# GOODFIRE PARKING EXPANSION

# SITE PLAN AMENDMENT APPLICATION

Subject: Comment Response Letter  
Goodfire Brewing Parking Expansion – Freeport, Maine

On behalf of MR 117 Route One, LLC, we are pleased to respond to the comments that we received from Gorrill-Palmer as part of the Site Plan Amendment peer review.

DRAWING NO.  
**C-20**

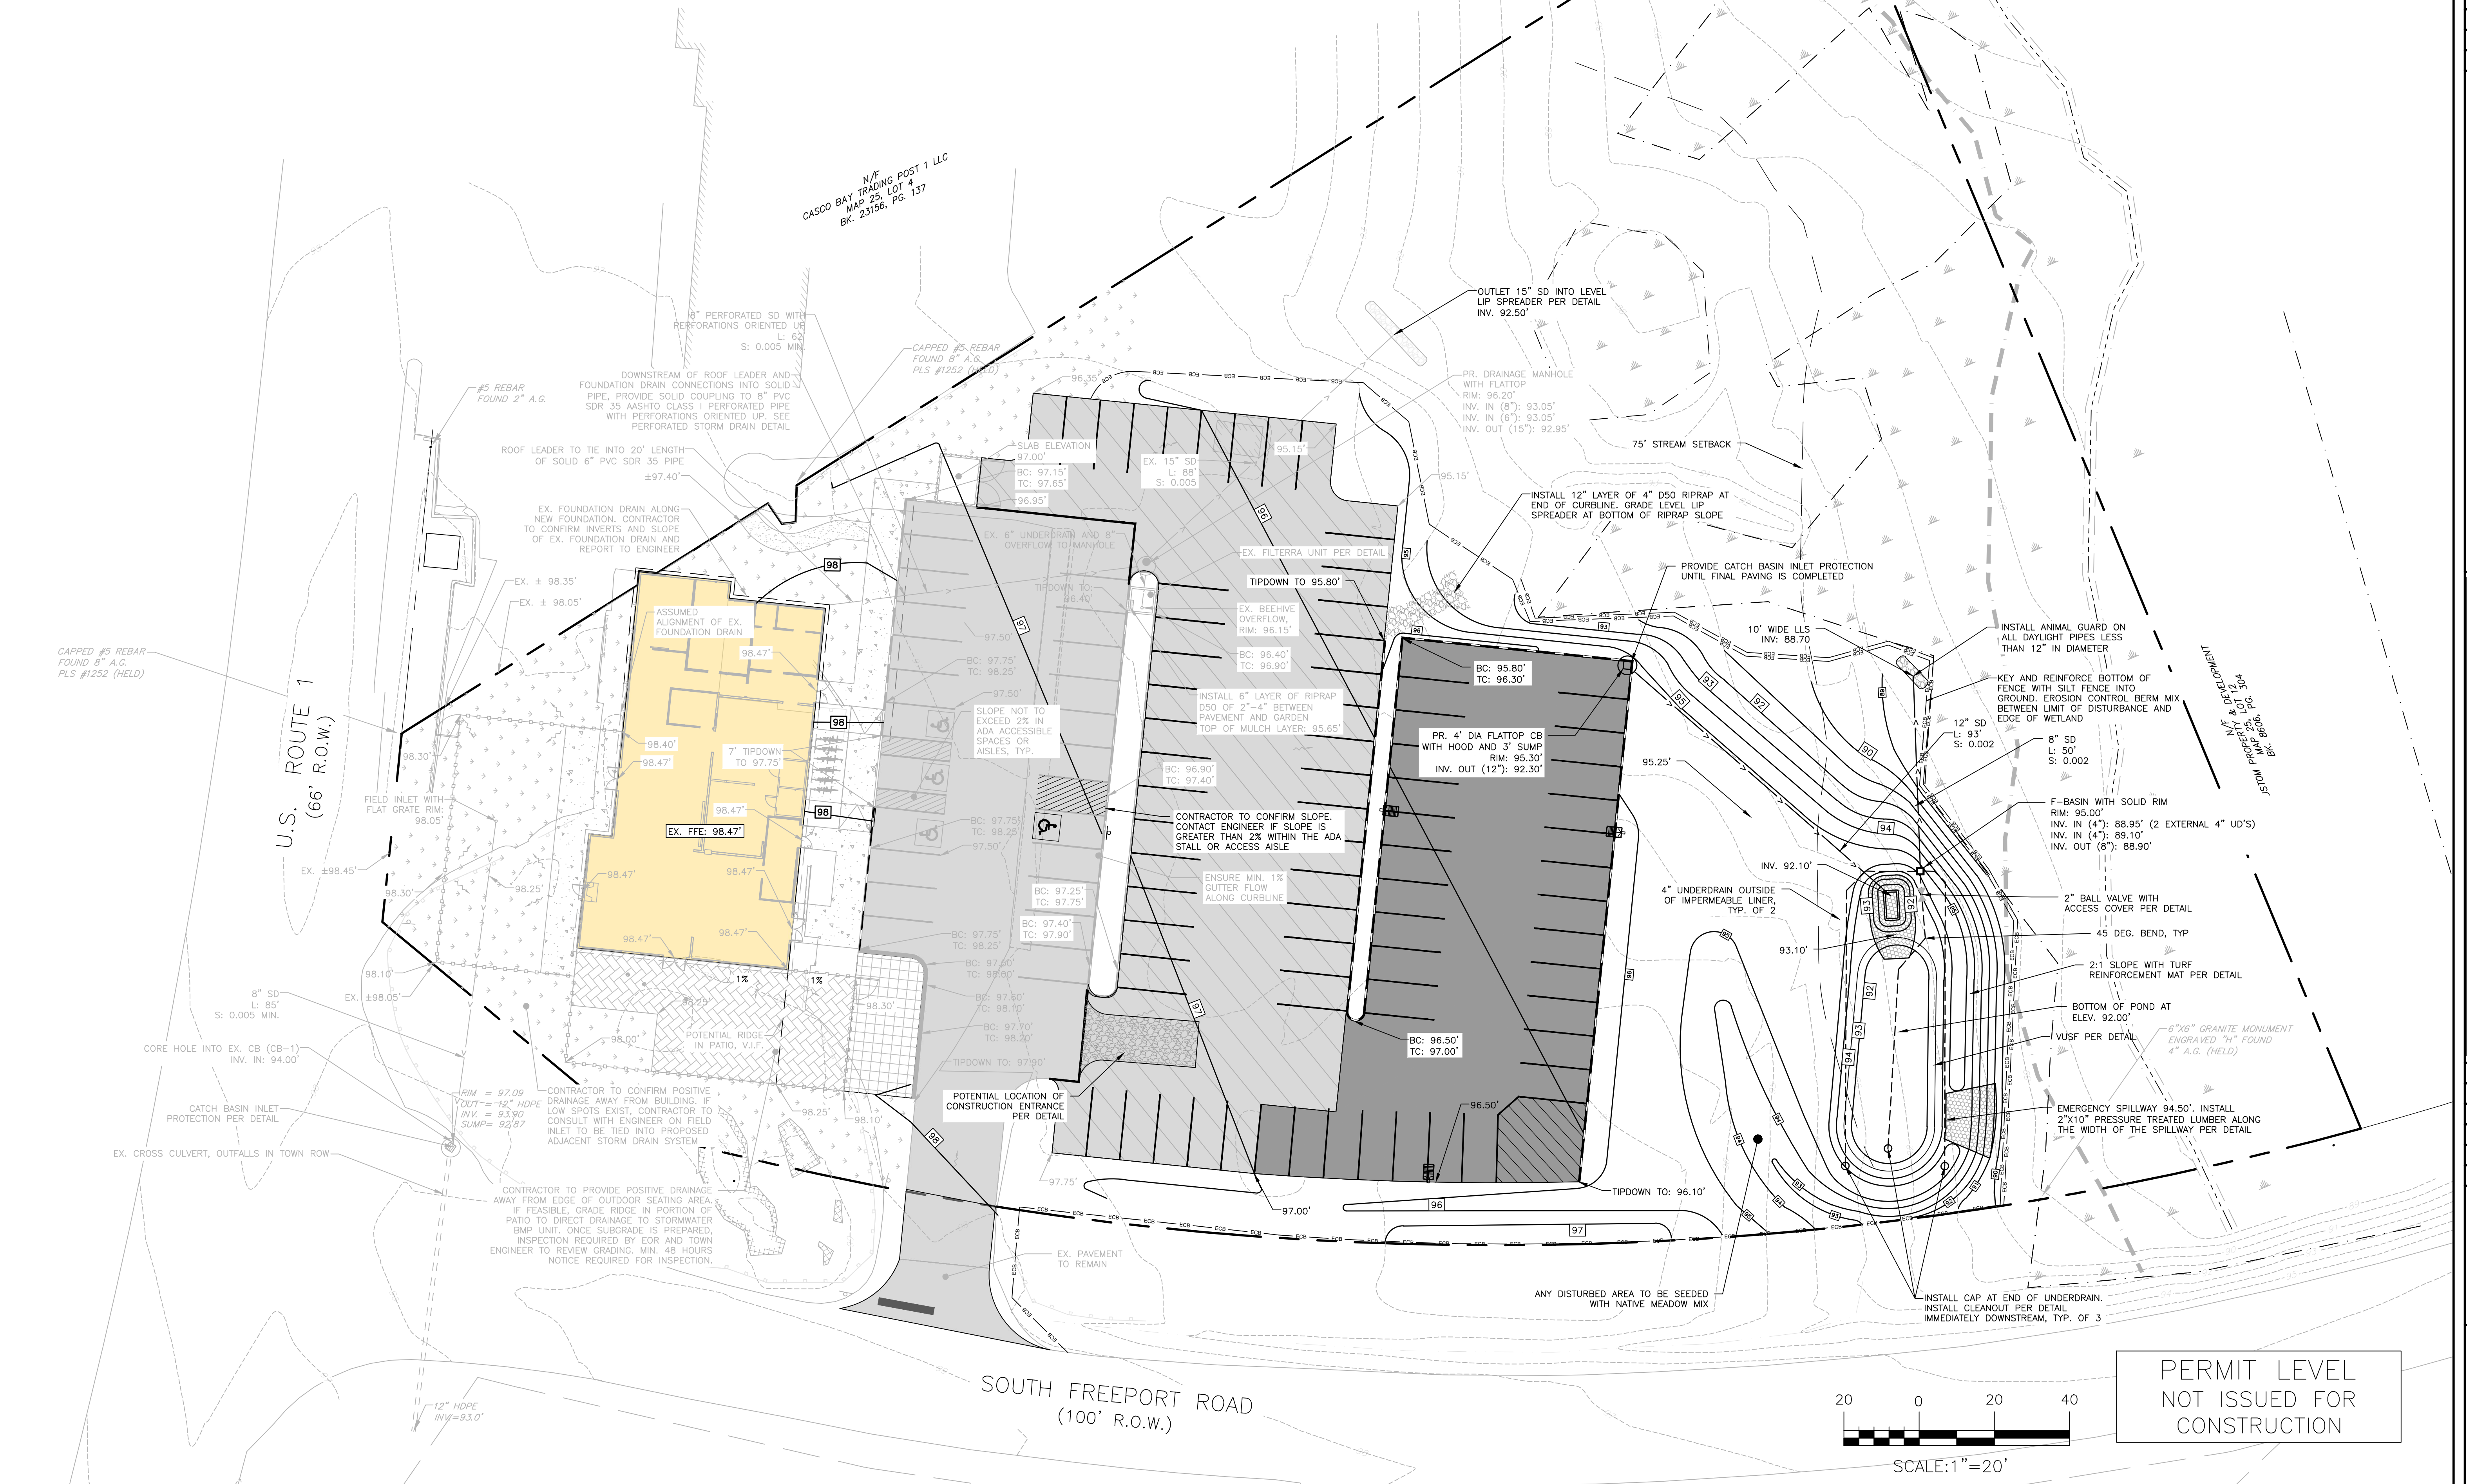
**Comment** – *Show the 75-foot stream setback on the grading plan.*

**Comment** – *We recommend a double row of sediment barriers at disturbance adjacent to the wetlands.*

**Comment** – *Show a temporary sediment barrier at the proposed catch basin.*

**Comment** – *Sheet C-20 calls out a cleanout, typ. of 2 but the cleanouts do not appear to be shown. We recommend that cleanouts be provided on all three underdrains.*

**Response** – The 75-foot stream setback is now being shown on the grading plan.

**Response** – The grading plan has been revised to indicate a double row of sediment barriers between the limit of disturbance and the wetlands.

**Response** – A callout has been added to the referenced catch basin to clarify inlet protection is required until the parking lot receives surface pavement.

**Response** – Sheet C-20 has been updated to show a cleanout for each of the three underdrains.

**LIGHT POLE BASE**  
NOT TO SCALE

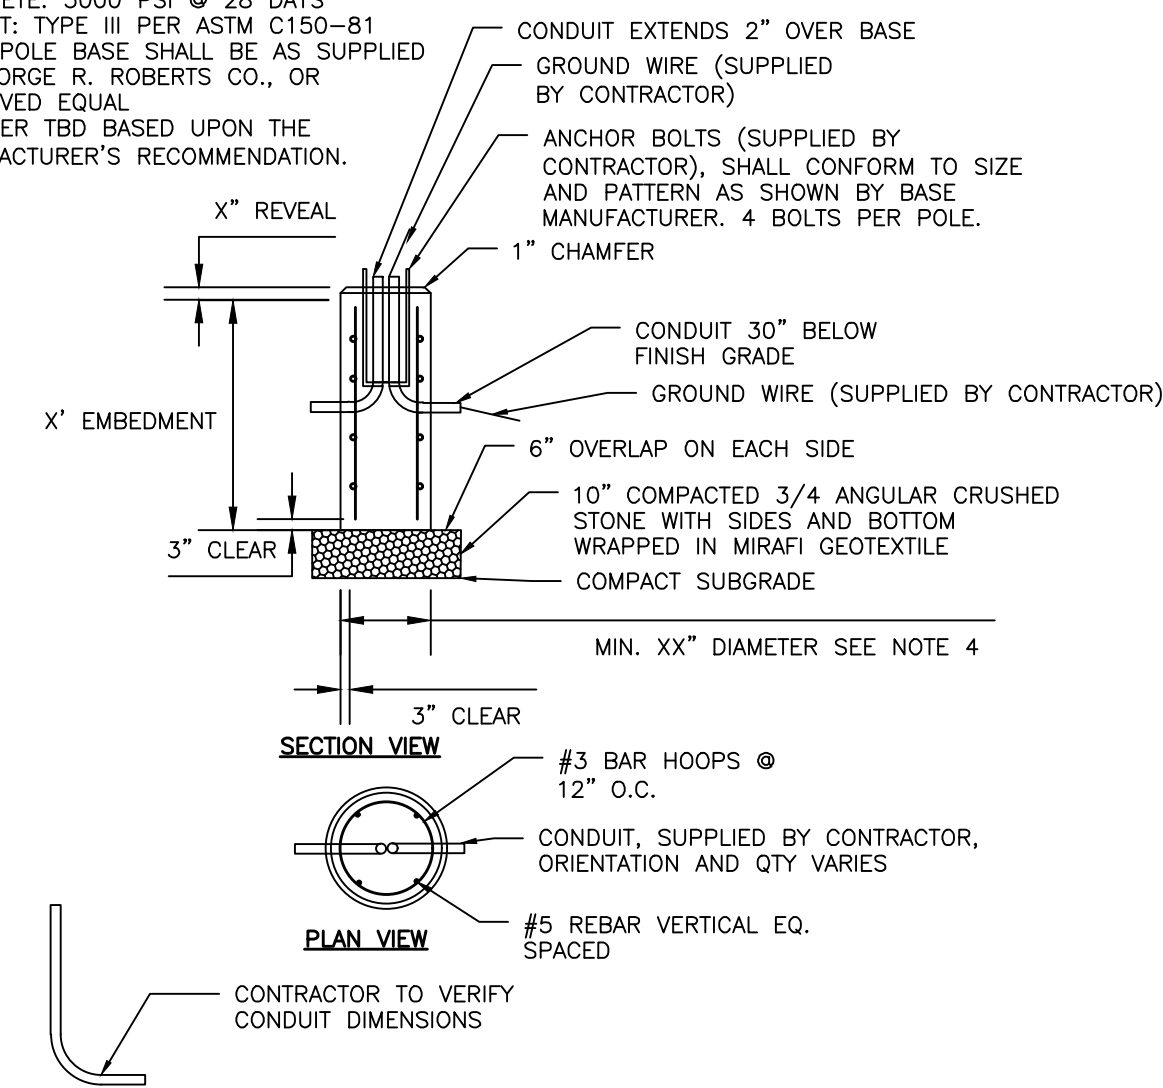
**Comment** – *Provide a light pole base detail.*

**Response** – A light pole base detail had been added to sheet C-30.

**LEVEL LIP SPREADER DETAIL**  
NOT TO SCALE

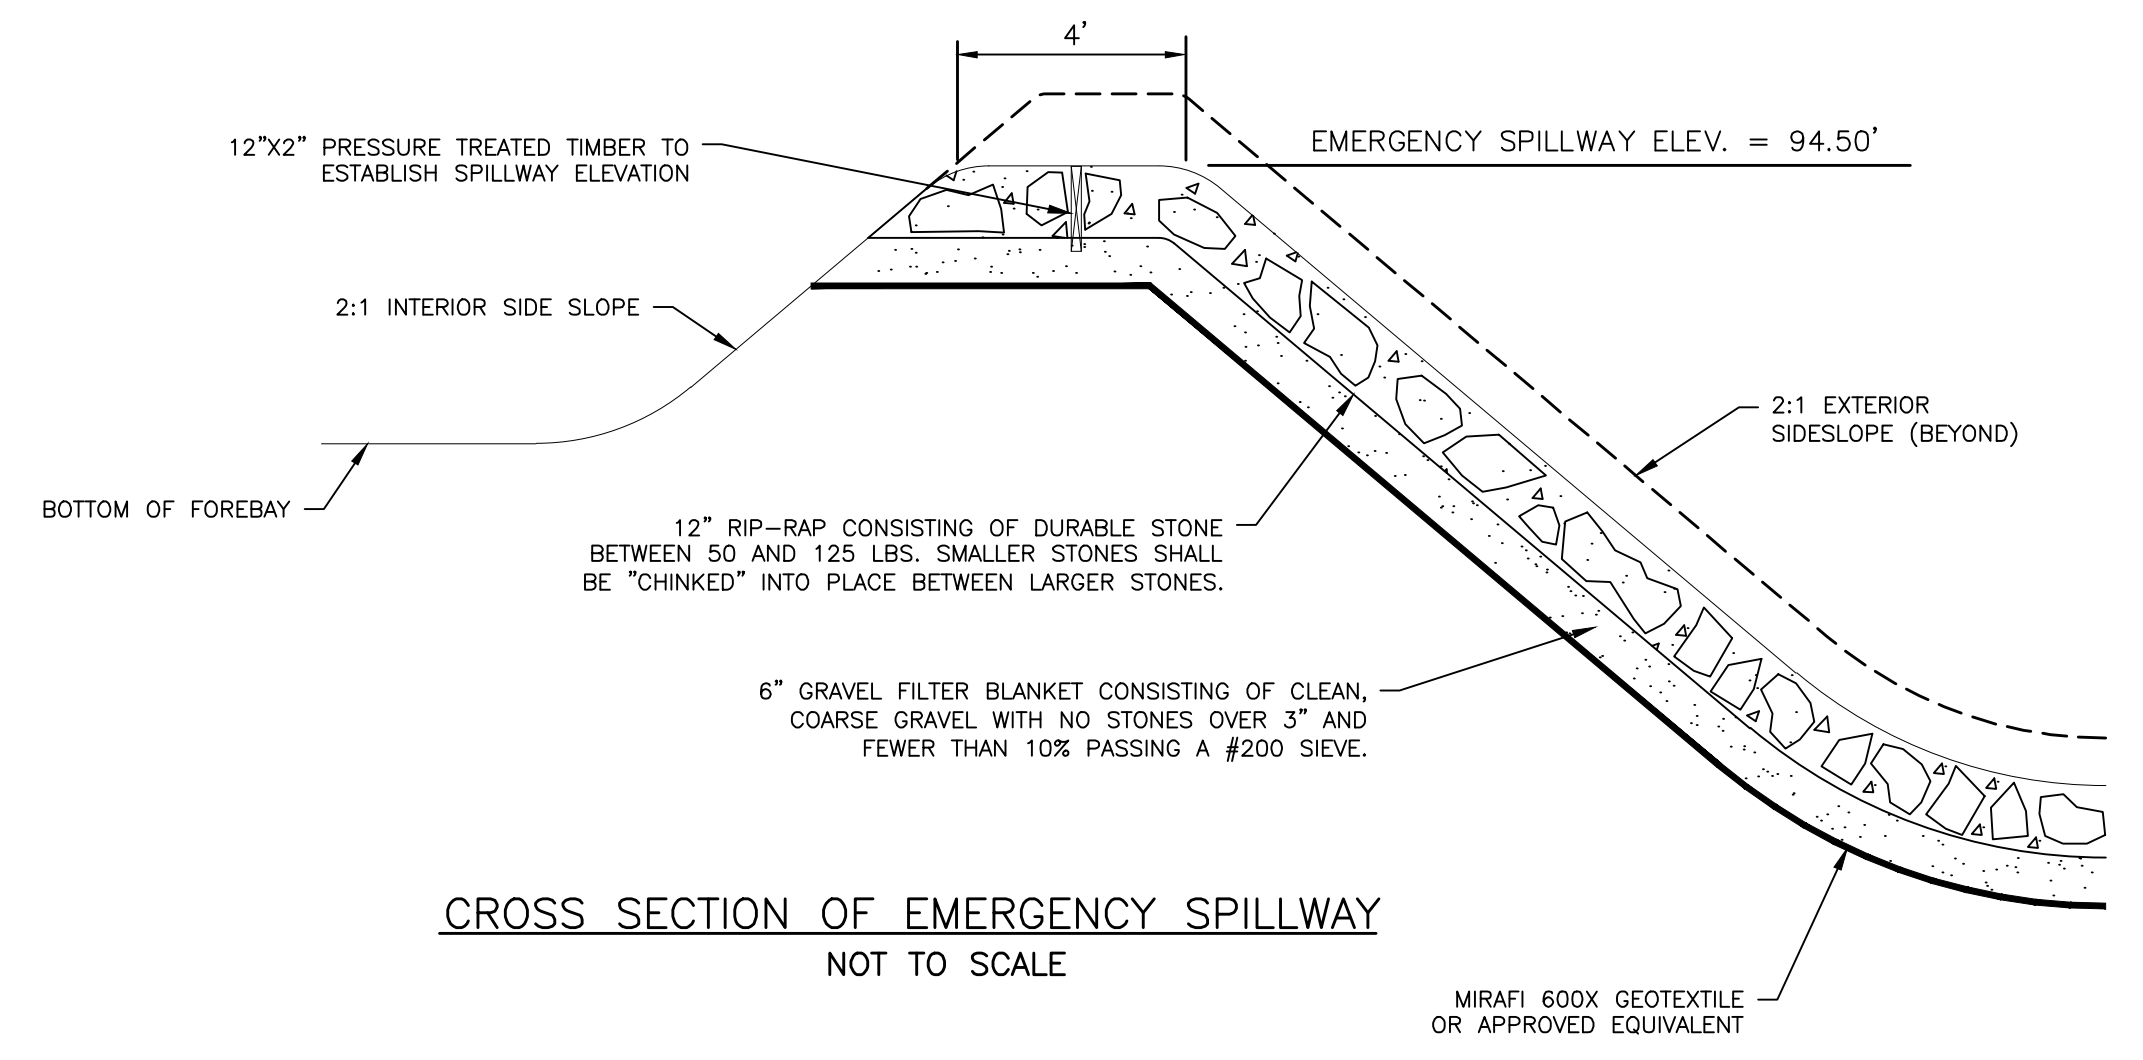
**Comment** – *Confirm the intended location of the geotextile fabric in the cross section of the level lip spreader detail. It is not clear what is intended given the line weights of the detail.*

**Response** – The fabric is proposed beneath the pipe outlet and under the stone berm before it is keyed into the ground to help mitigate erosive forces on the subgrade. Sheet C-32 has been revised to reflect this.

**VEGETATED UNDERDRAINED SOIL FILTER DETAIL**  
NOT TO SCALE

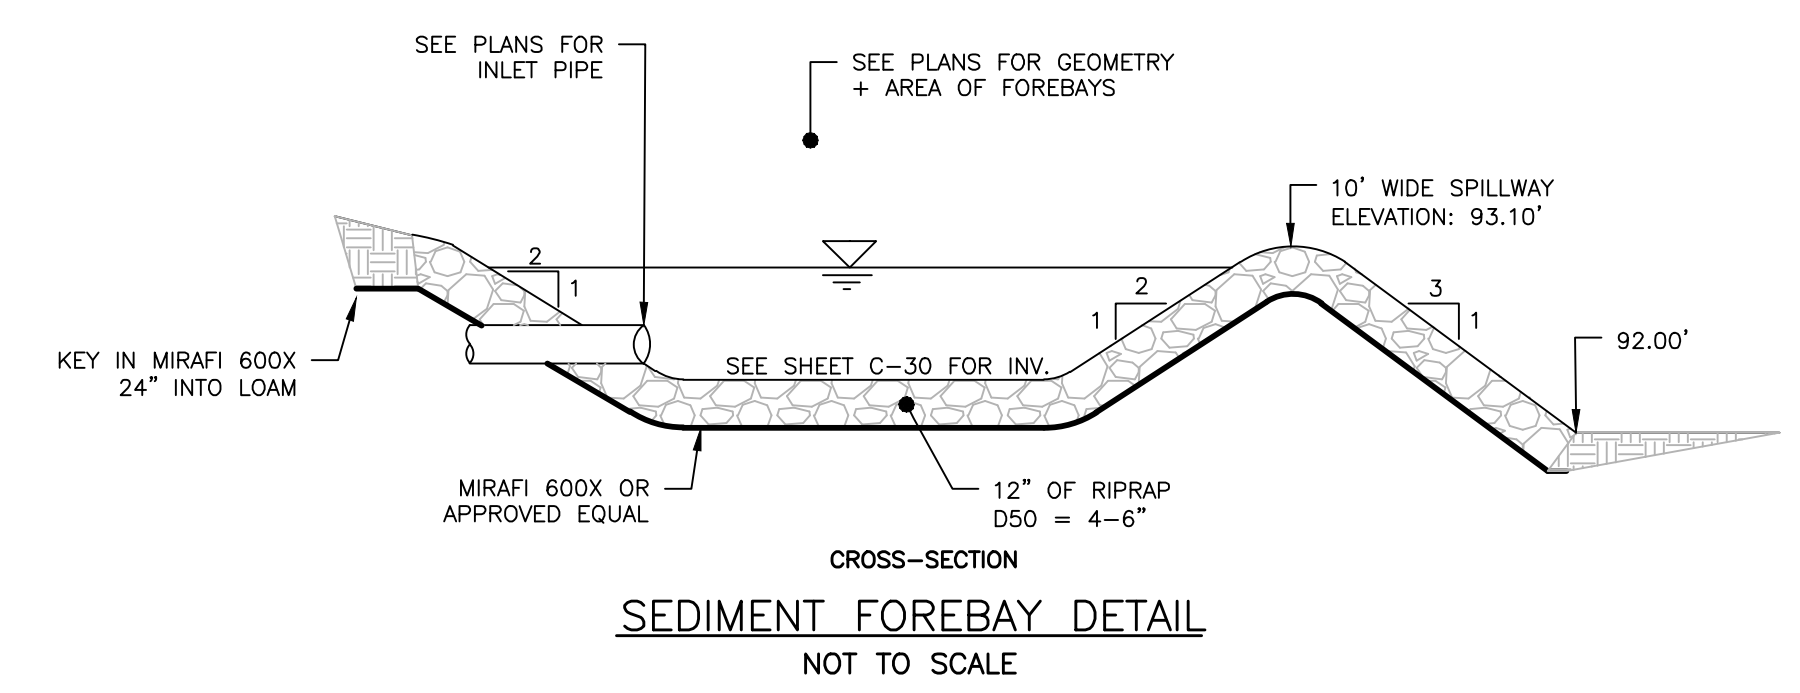
**Comment** – *The proposed vegetated underdrained soil filter appears to be a composite of a MDEP grassed underdrained soil filter and a MDEP bioretention filter. The pond detail notes that plants for vegetating the pond will be selected by a Landscape Architect. If it is not intended to be planted, revise the notes accordingly. Given the proposed ponding depth of approximately 2.5 feet for the 25-year storm, and the slow release of the runoff through the underdrain, the pond will likely contain water for a longer time and a greater depth than will allow for the survival of plants other than grass. Although it will likely not affect the provided water quality volume, the soil filter voids can be used to provide water quality volume for a bioretention pond, but not for a grassed underdrained soil filter. We recommend revising the pond calculations, design, and details to conform to either a bioretention filter or a grassed underdrained soil filter.*

**Response** – The referenced BMP is proposed to be a vegetated (or grassed) underdrained soil filter (VUSF). It is not proposed to feature elements of a bioretention cell and as such, we have removed any reference to plantings. Additionally, the water quality volume in table 2 has been clarified to include solely the first 18" of ponding that occurs above grade. Additional storage is provided above that 18" to attenuate peak flows during larger storm events, but is not included in the water quality volume calculations. Lastly, while the HydroCAD includes a 10% void ratio within the filter profile to accurately model the VUSF's storage capabilities, this storage is not included within the water quality volume calculations.

It should also be noted that the pond has been enlarged slightly (bottom of pond filter increased by 100 sf); this design change was performed to ensure that the potential future site build out would not exceed the VUSF filter area requirements of 5% tributary impervious area plus 2% tributary landscaped area. A revised stormwater report has been included with this resubmission to demonstrate the changes in filter area and water quality volume. The peak flow rates from the 2, 10, and 25 year storms remain unchanged when compared to the previous submission.
